City Planning Commission  
Sacramento, California

Subject: A. Negative Declaration  
B. Special Permit Time extension to develop six "petite homes"  
and one halfplex in the Single Family Alternative (R-1A) zone.

Location: 2840 Taft Street

APPLC. NO. P88-267

# EXHIBIT B ELEVATIONS

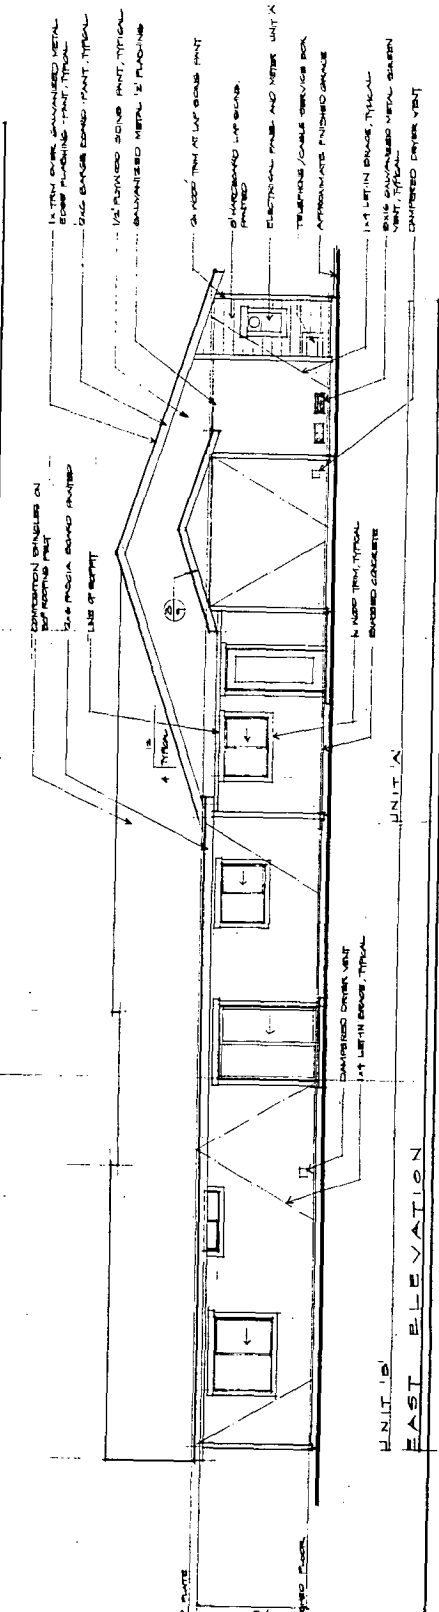
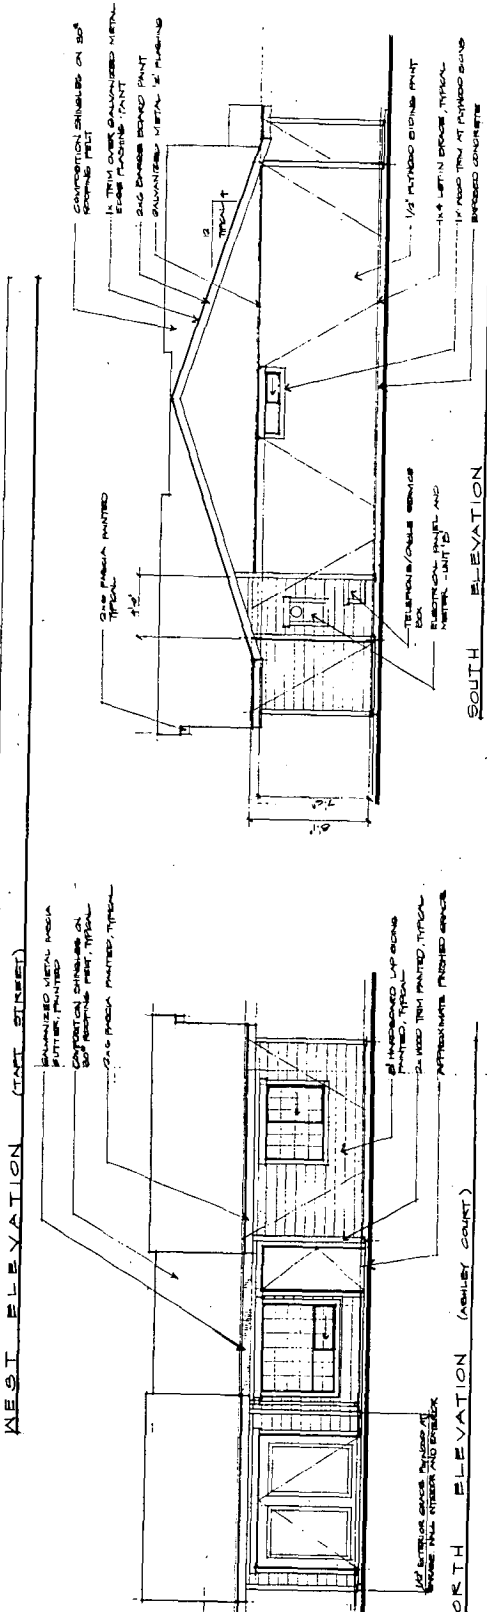
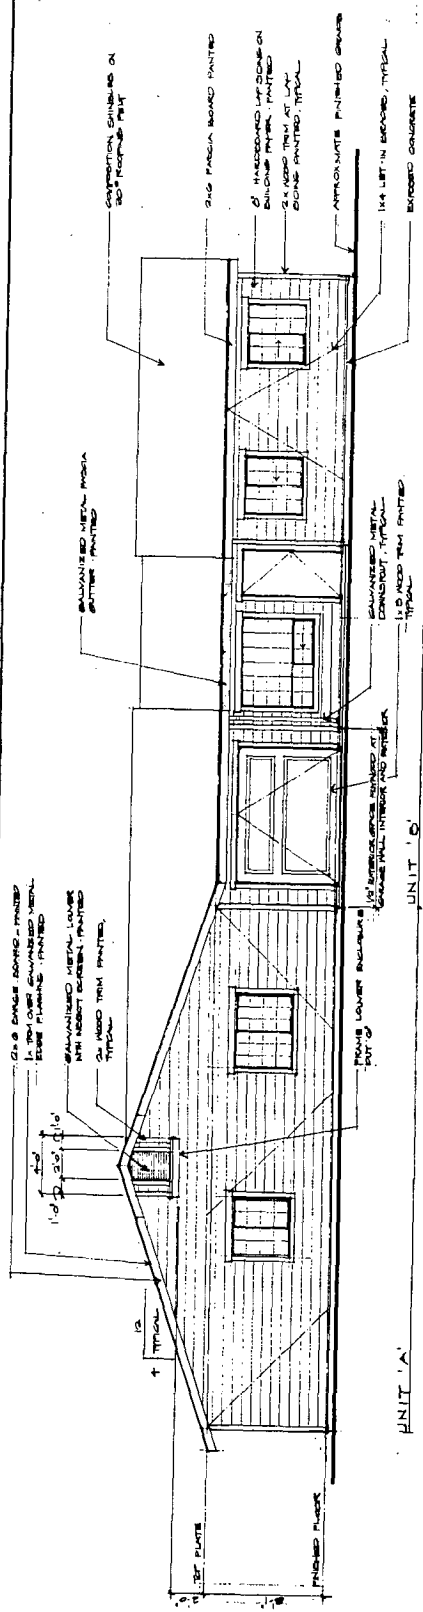
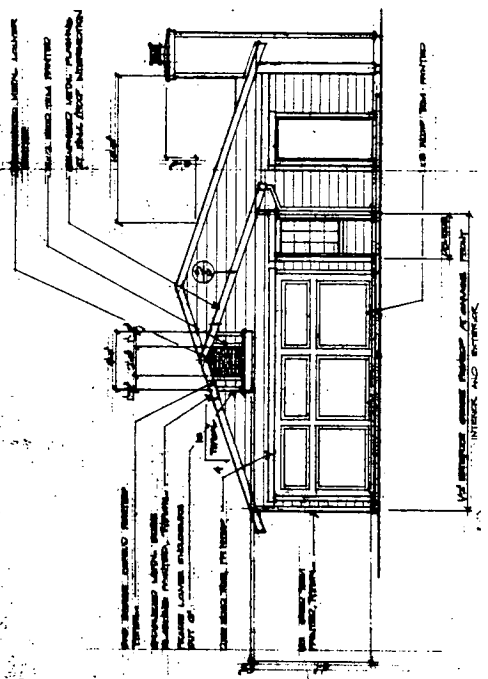
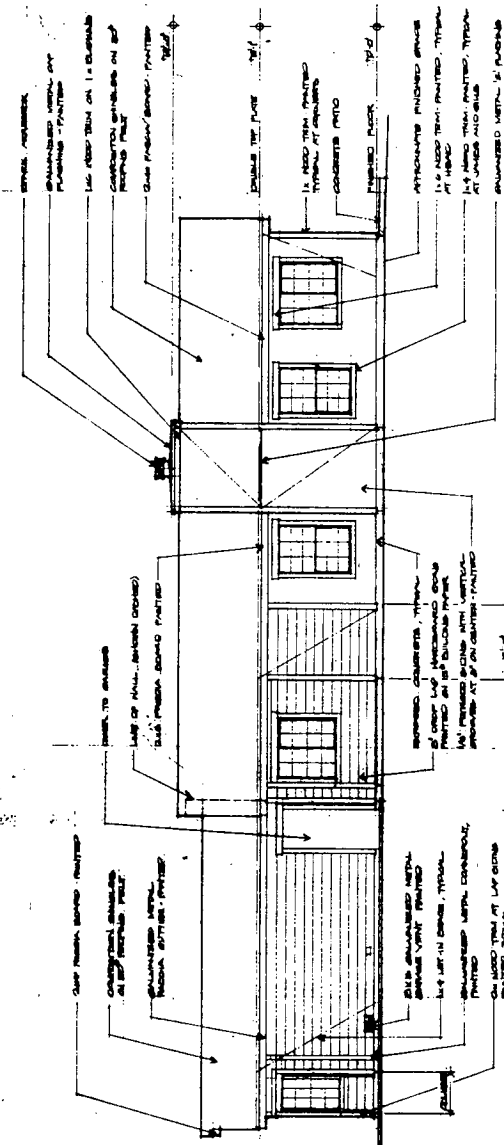
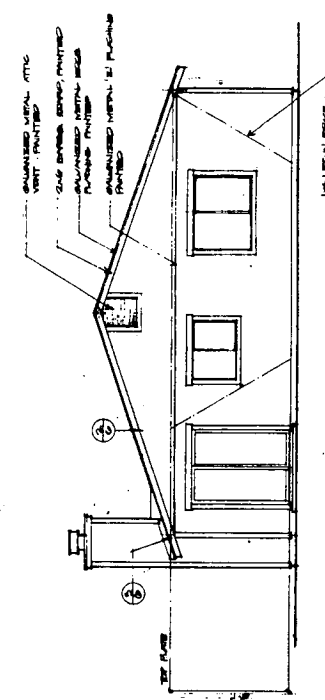
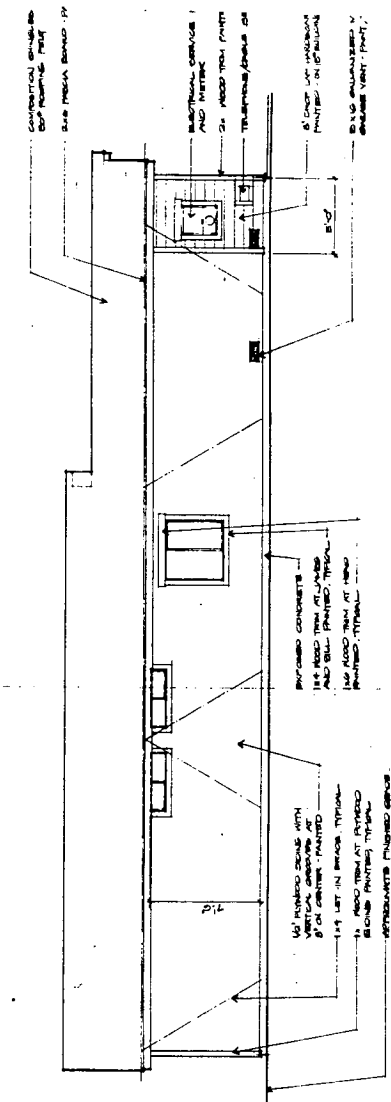
5. In order to provide some variation in the elevations of the six units, staff recommends alternating the roof lines of the garages with a gable (Exhibit B) and a dutch gable (Exhibit E). To provide further variation staff recommends utilizing four inch, six inch and eight inch siding. Two units should be constructed with four inch siding, two units with six inch siding and two units with eight inch siding.

5. The applicant shall utilize a gable or dutch gable roof line on the garages of every other unit.
6. The applicant shall utilize four inch, six inch and eight inch siding on the units. Two units shall be constructed with four inch siding, two units with six inch siding and two units with eight inch siding.

# EXHIBIT D

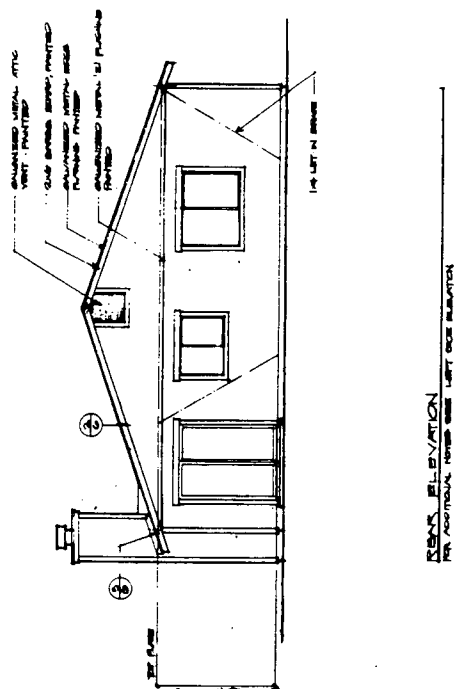
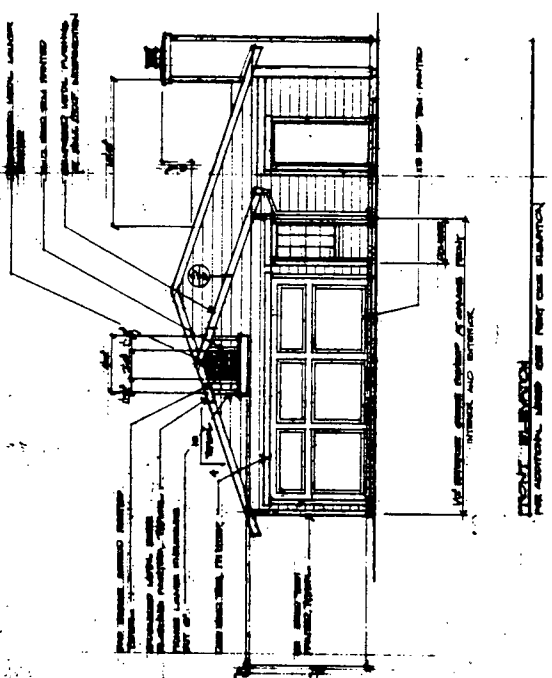
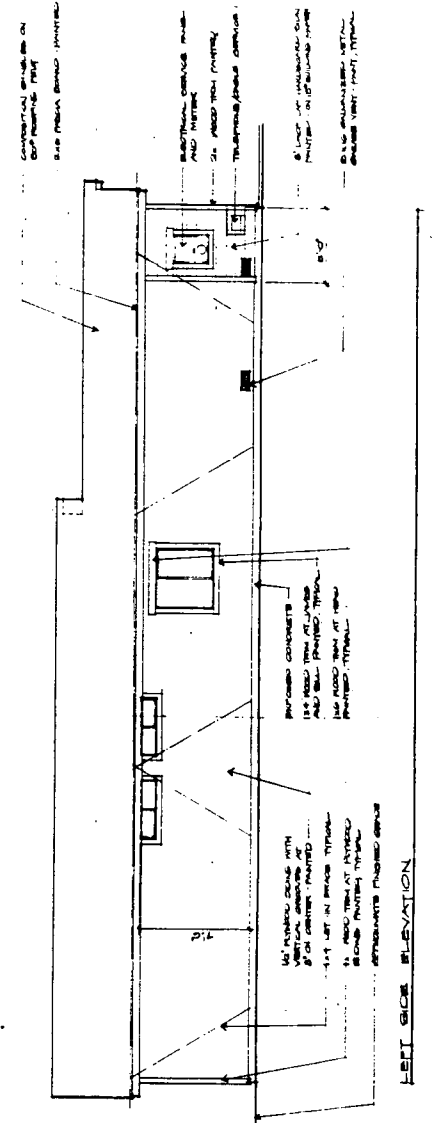
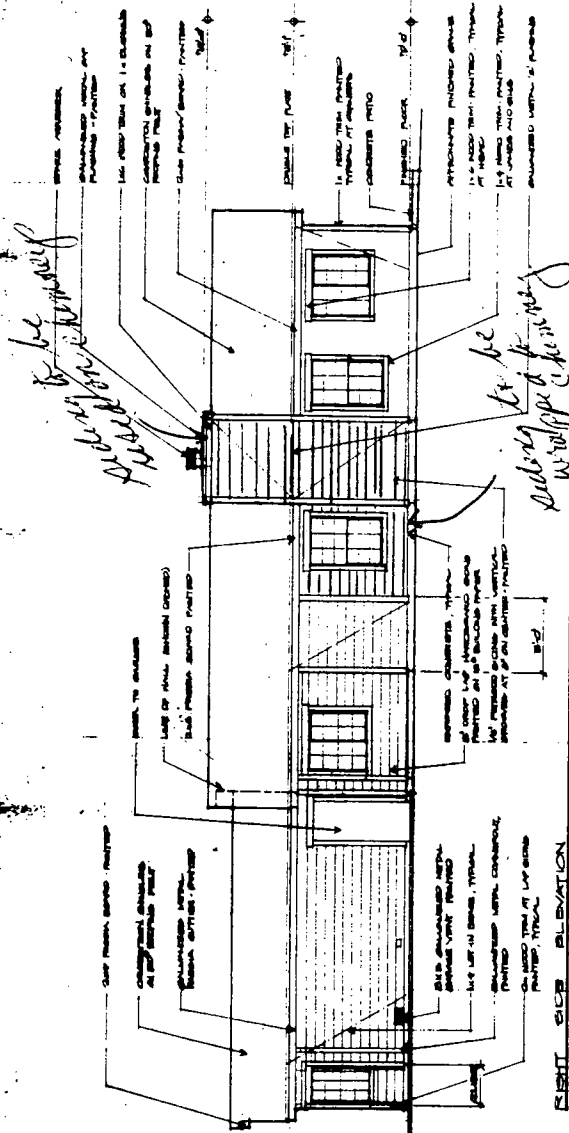
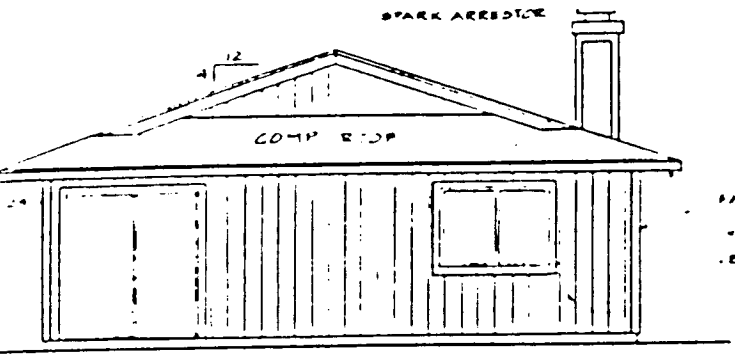
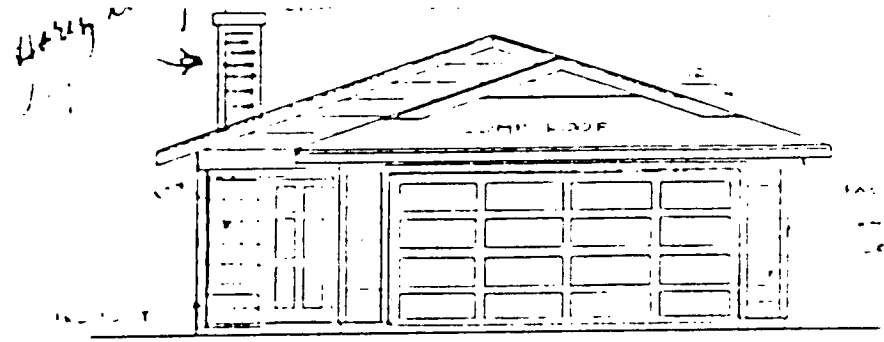
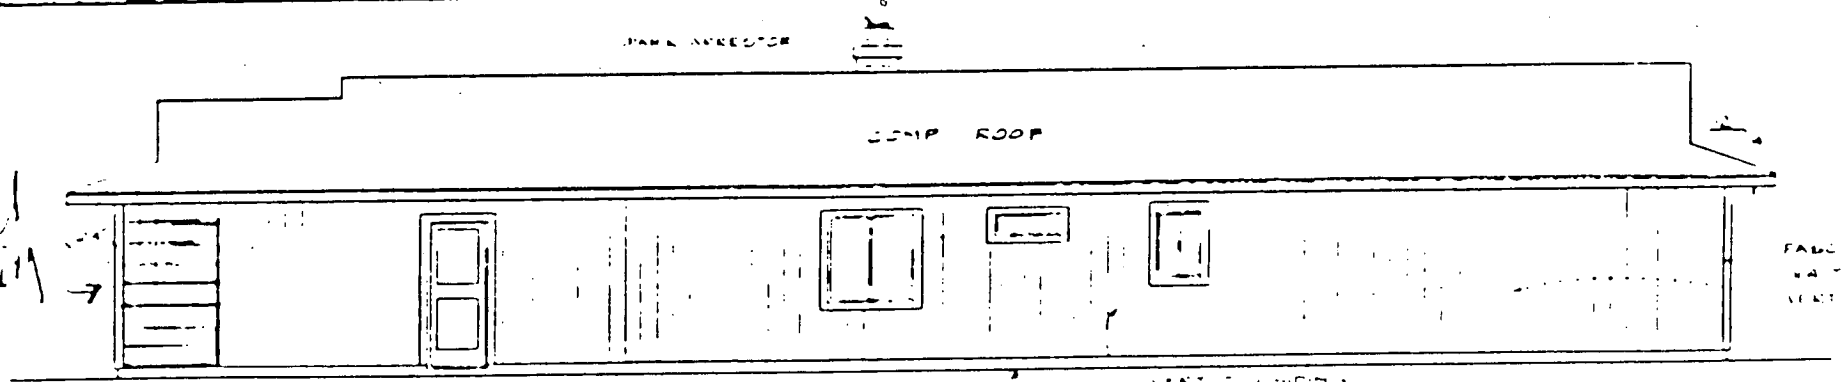
3. The masonite horizontal lap siding should be wrapped on the right side elevation to the chimney (Exhibit D).
4. The applicant should use the masonite horizontal lap siding on the three sides (north, east and west) of the chimneys (Exhibit D).

3. The masonite horizontal lap siding shall be wrapped on the right side elevation to the chimney.
4. The applicant shall use the masonite horizontal lap siding on the three sides (north, east and west) of the chimneys.
